***Replacement of T1 & T2 at Cobden TS
Notification of Conditional Approval of Connection Proposal
CAA ID Number: 2012-EX626***

Final Report - Expedited System Impact Assessment
Hydro One Networks Inc.

1.0 GENERAL DESCRIPTION & PROPOSED MODIFICATIONS

Figure 1 – T1/T2 DESN Load at Cobden TS

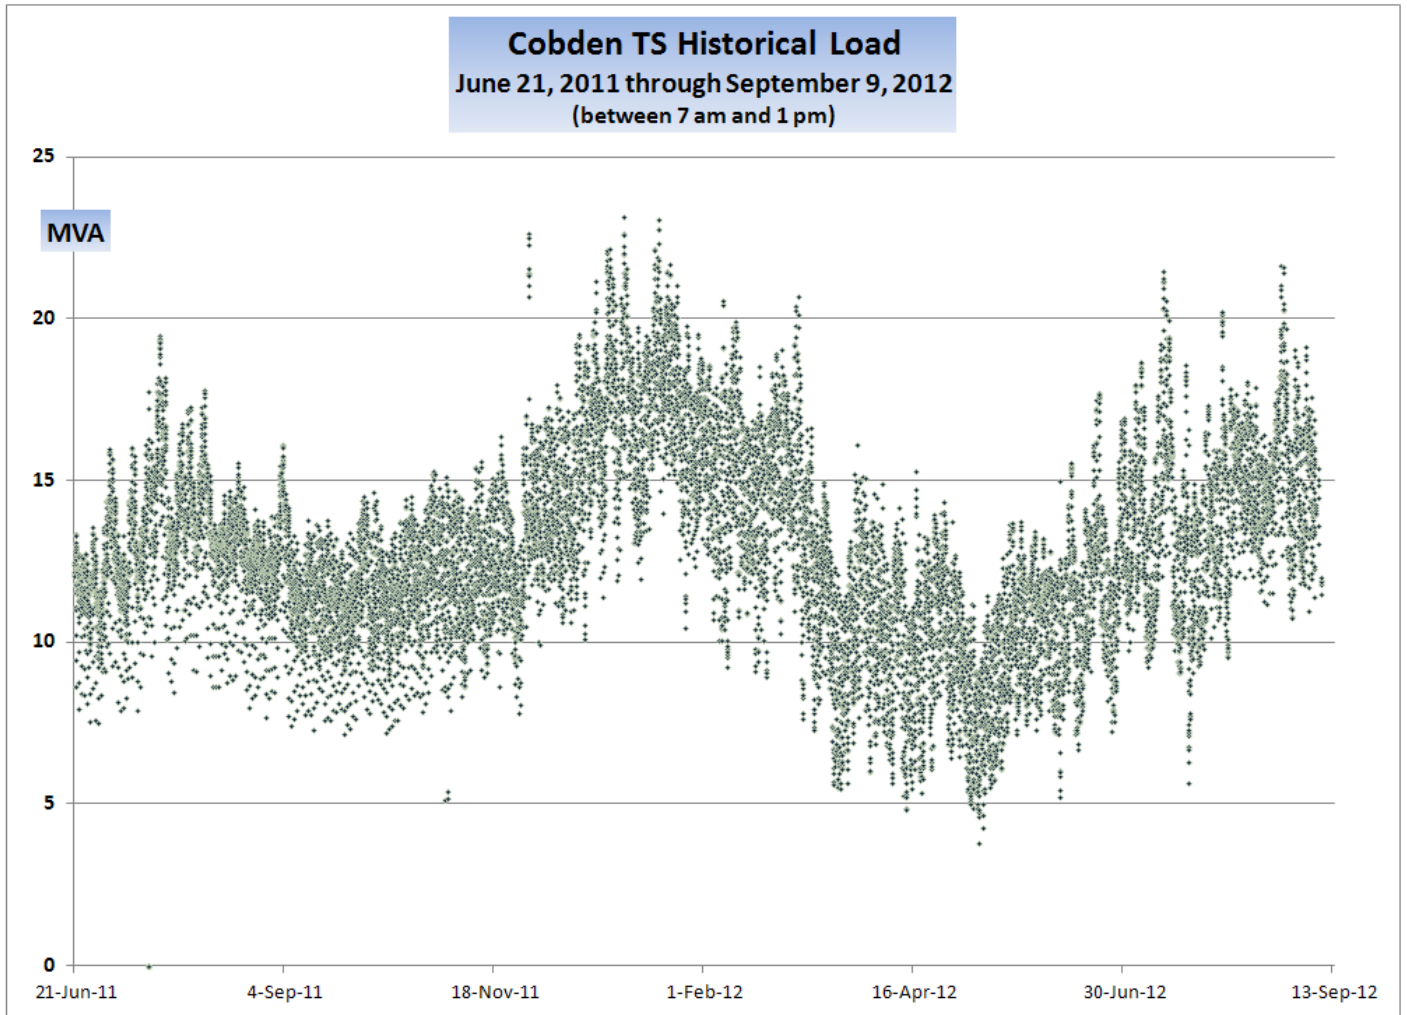
The peak load at Cobden TS is lower than the current 10-DAY winter capability of 28.8 MVA.

Figure 2 – Load Angle at Cobden TS

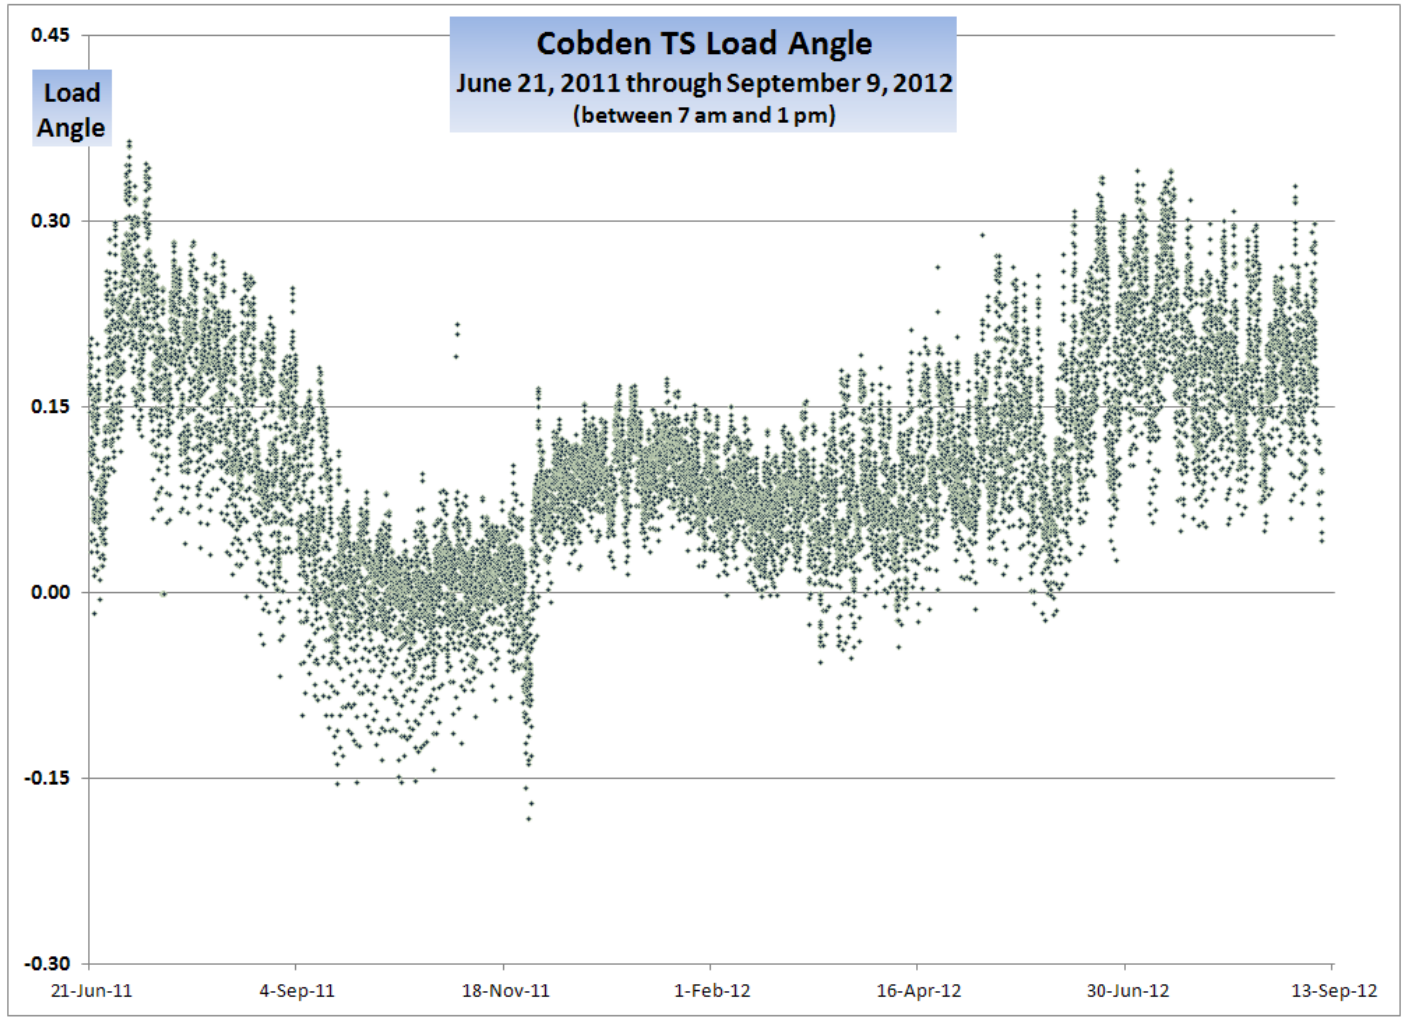
Between June 21, 2011 and September 9, 2012, the load angle at Cobden TS was within the IESO required limits.
